**STAFF REPORT**  
CONCERNING APPLICATION FOR A  
**CERTIFICATE OF APPROPRIATENESS**

**Application Number:** 2018-0621C

**Property Location:** 815 Arch

**APPLICATION ITEMS:** “Replacing railing with vinyl railing.”

**Premium Colonial 6' Rail Kit**

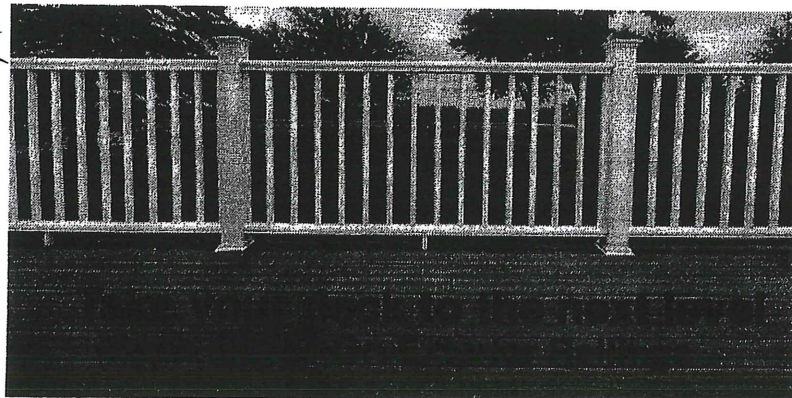
1. Replace existing wooden railing with multiple spans of 72” x 36” White Vinyl “Premium Colonial 6’ Rail Kit”

Staff recommends that the application be denied based upon the requirements of the Standards and Guidelines.
